Vibration from Engine after Cold Soak

Service Category Engine/Hybrid System

Section Engine Mechanical

YEAR(S)	MODEL(S)	ADDITIONAL INFORMATION
2010 – 2011	Prius

Figure 1.

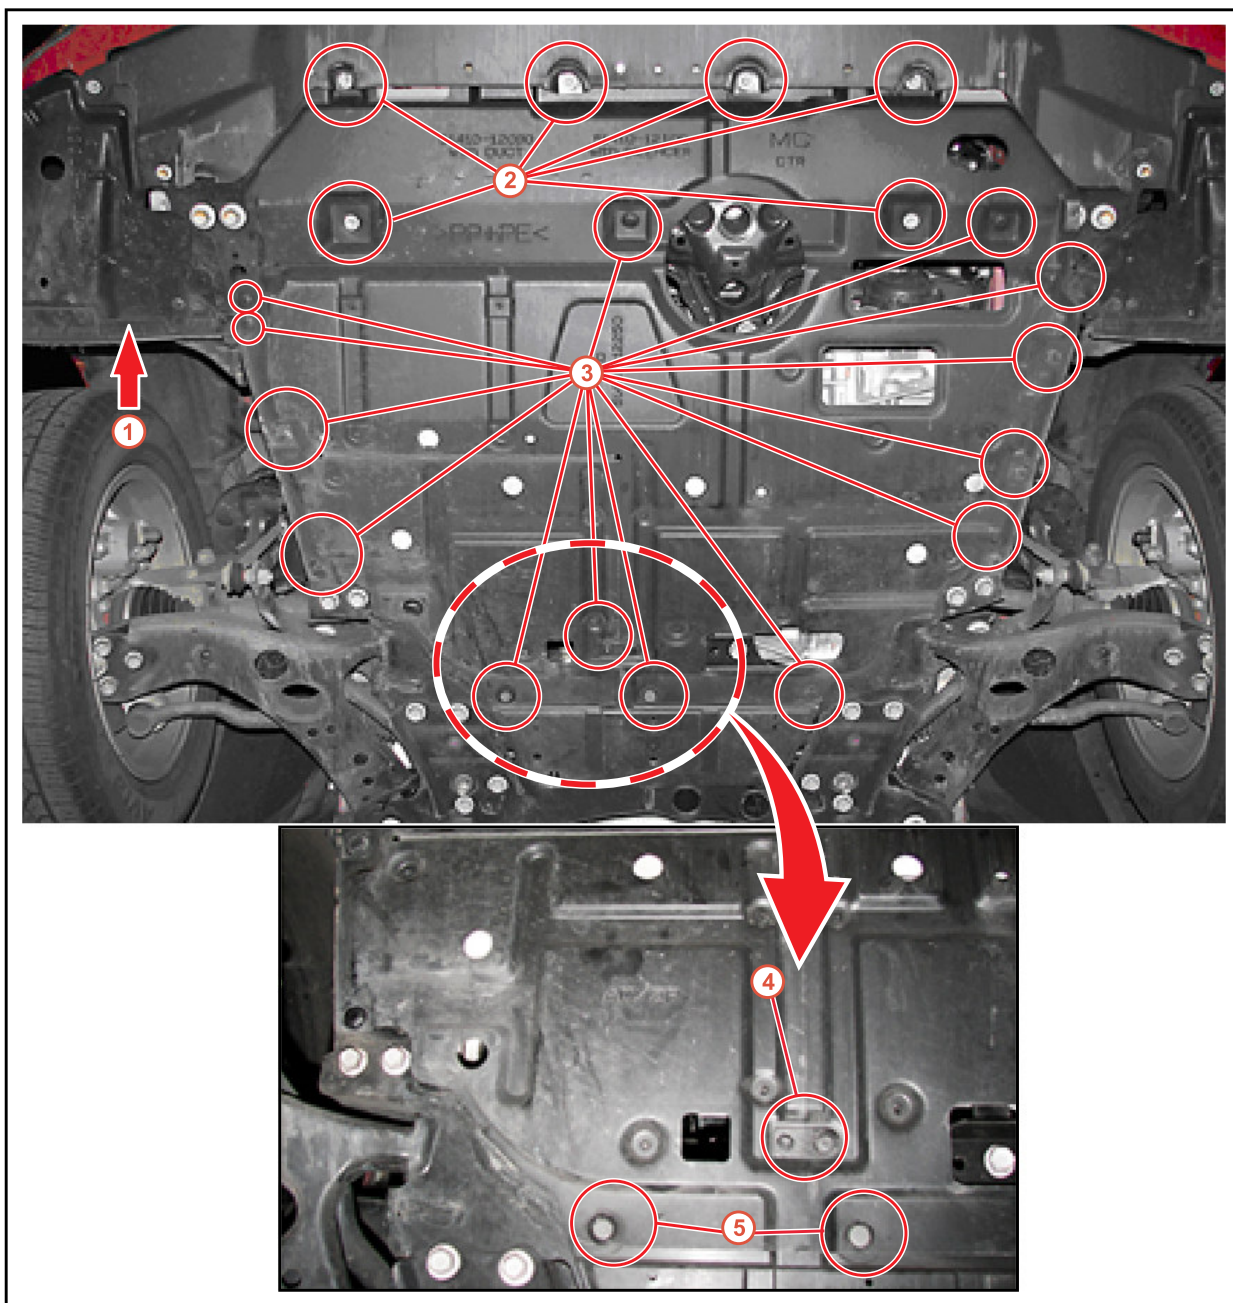
Remove the 6 bolts and 14 retaining clips from the engine under cover and slide toward rear of vehicle to remove cover.

Clips are not interchangeable. See Figure 1 for specific clip locations.

5. Reposition the engine under cover into place and install the 14 retaining clips in their correct locations, then install the 6 bolts (See Figure 1).

Figure 2.

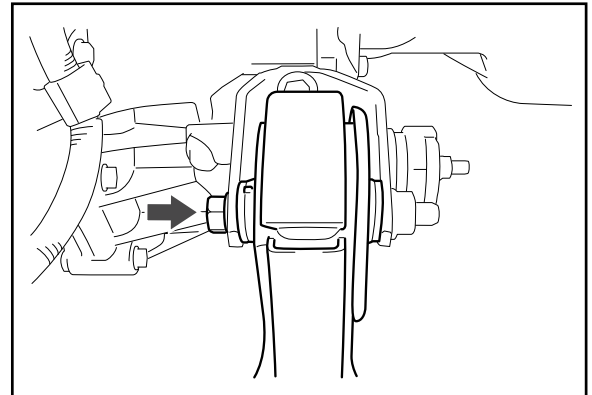
3. Properly support the engine assembly with a jack and remove the two bolts from the right rear engine mount.
4. Install the new rear engine mount and properly torque bolts.

Torque: 95 N*m (969 kgf*cm, 70 ft*lbf)
